**PREVOST**

**WARRANTY  
BULLETIN**

Wb98-19

| SUBJECT : WARM AIR BAFFLE |              |

FIGURE 1 : ENGINE RADIATOR DOOR

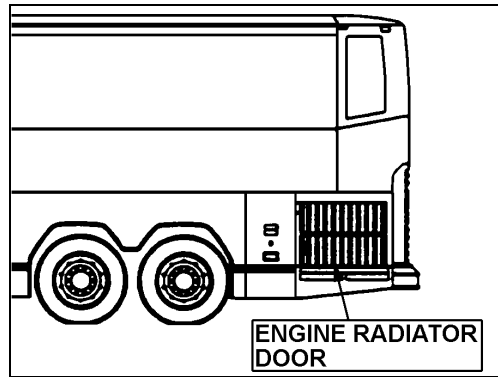
1. Go under engine radiator door and insert the warm air baffle between the muffler and chassis. Lean the angular bracket against the interior edge, slide baffle towards front of vehicle to the maximum then go backwards 3/8 inch (9 mm) (refer to figures 1 and 2).
2. Trace a line on the chassis 3/8 inch (9 mm) from baffle interior corner (refer to figure 2).

FIGURE 2 : H3 SERIES COACHES WARM AIR BAFFLE

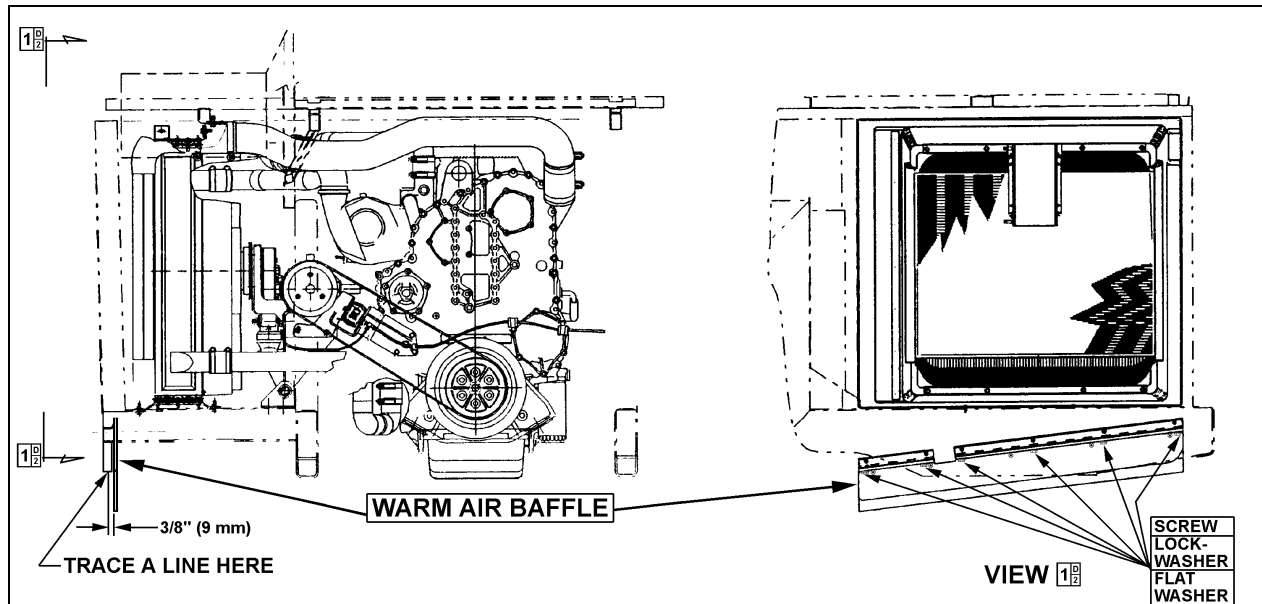
4. Secure warm air baffle using six screws, lock washers and flat washers (refer to figure 2).

FIGURE 3 : H3 SERIES VEHICLES DRILLING DIAGRAM

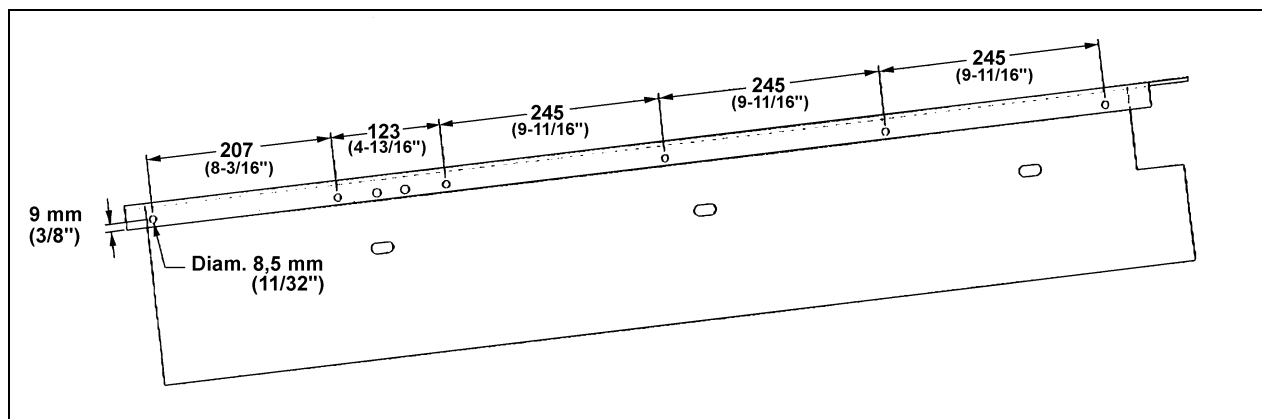
3. Drill six 11/32 inch (8,5 mm) holes into the chassis using drilling diagram in figure 3.

**Note :** Measurements between holes starting from the first hole must be as accurate as possible.

FIGURE 4 : ENGINE RADIATOR DOOR

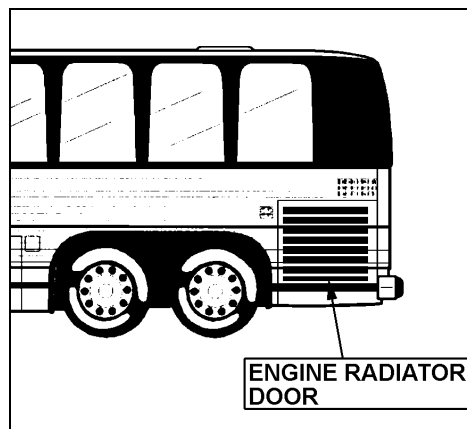
1. Open engine radiator door, remove holding strap from door and also door stop located at bottom R.H. side corner (refer to figures 4 and 5).

FIGURE 5 : XL-40 AND XL-45 COACHES WARM AIR BAFFLE

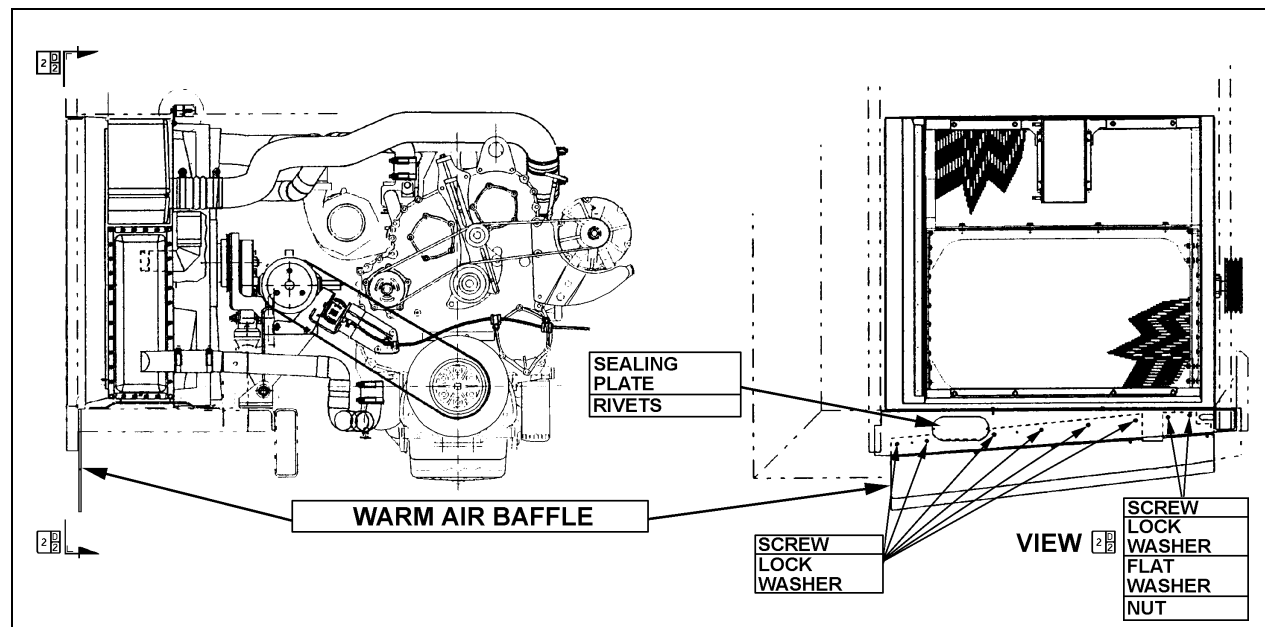
4. Use 6 screws and 6 lock washers for the six L.H.side holes and use 2 screws, 2 lock washers on exterior side and 2 flat washers and 2 nuts between muffler and chassis for the two R.H.side holes (refer to fig. 5).

3. Use sealing plate as template and center it over the bolt access orifice in order to drill rivet holes, use a 3/16 inch drill bit. Fix sealing plate using two rivets.
4. Use 6 screws and 6 lock washers for the six L.H. side holes and use 2 screws, 2 lock washers on exterior side and 2 flat washers and 2 nuts between muffler and chassis for the two R.H. side holes (refer to fig. 5).

FIGURE 6 : XL SERIES VEHICLES DRILLING DIAGRAM

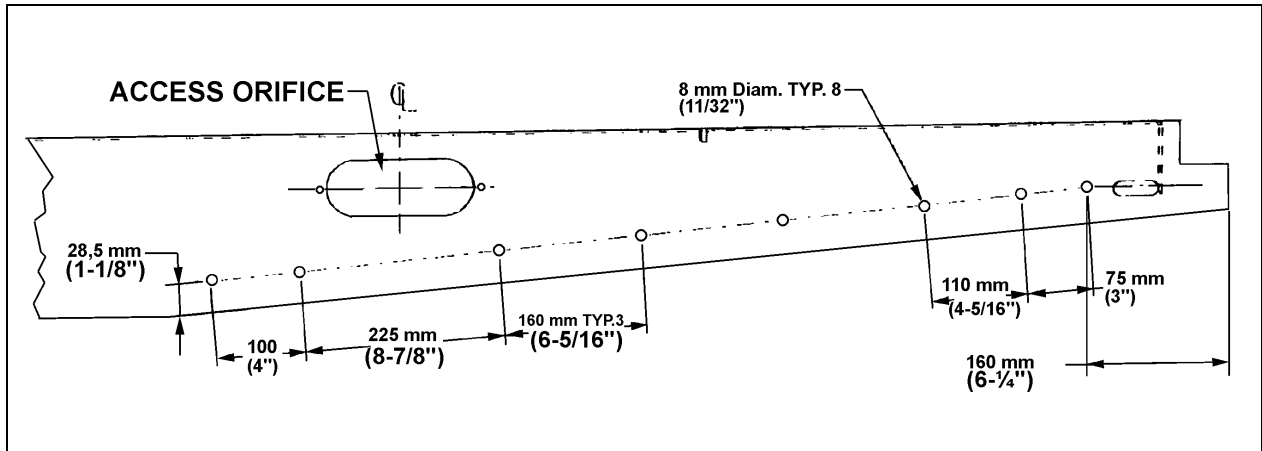
2. Drill eight 11/32 inch (8 mm) holes into the coach chassis using drilling diagram as a reference (refer to figure 6).

**Caution :** Ensure to drill through the vehicle chassis only, avoid damaging the muffler.

**Note :** Measurements between holes starting from the first hole must be as accurate as possible.

FIGURE 7 : ENGINE RADIATOR DOOR

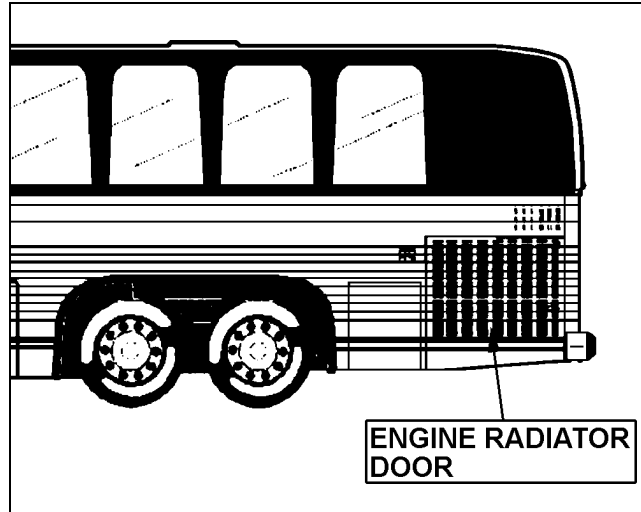
1. Open engine radiator door, remove holding strap from door and also door stop located at bottom R.H. side corner (refer to figures 5 and 7).
2. Drill eight 11/32 inch (8 mm) holes into the coach chassis using drilling diagram as a reference (refer to figure 6).
